MONTGOMERY COUNTY HISTORIC PRESERVATION COMMISSION STAFF REPORT

15215 Barnesville Rd., Boyds

18/8-17B

Demolition of non-historic accessory structures and other alterations

Site Plan

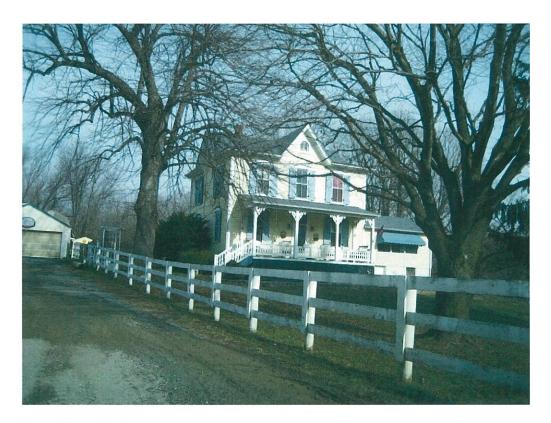
The four (4) outbuildings to be removed include two sheds, a gambrel roof barn, and a truck shelter, all of which are attached to a c. 1958 garage (the truck shelter being attached to the left side and all others being attached to the rear). According to the applicant, the outbuildings to be removed are non-historic, with only the garage appearing in historic photographs.

While the outbuildings to be removed are consistent with the rural characteristics of the Boyds Historic District, they do not contribute to the Gothic Revival-style historic house. Staff finds that, in accordance with the *Standards*, the outbuildings can be removed without altering the features and spaces that characterize the resource. Because the majority of outbuildings to be removed are attached at the rear of the garage, the overall visual impact to the subject property from the public right-of-way will likely be minimal.

The swimming pool to be removed is non-historic, at grade, and at the rear of the property. The swimming pool does not contribute to the historic character of the property and is inconsistent with the rural characteristics of the Boyds Historic District. In accordance with the *Standards*, the swimming pool can be removed without altering the features and spaces that characterize the resource. Staff suggests that the removal of the non-historic, historically incompatible swimming pool will enhance the preservation of the subject property and surrounding historic district.

The timber wall to be removed is non-historic and at the rear/right side of the subject property. Although the timber wall appears to be at least 3' tall, it is not a visually prominent feature of the subject property, due to its location and the depth of the lot. Overall, the timber wall is consistent with the rural characteristics of the Boyds Historic District and the subject property, but, because the wall is non-historic, it can be removed without altering the features and spaces that characterize the resource, in accordance with the *Standards*.

Staff recommends that the Commission <u>approve</u> the HAWP application under the Criteria for Issuance in Chapter 24A-8(b), having found that the proposal will not substantially alter the exterior features of the historic resource and is compatible in character with the district and the purposes of Chapter 24A;
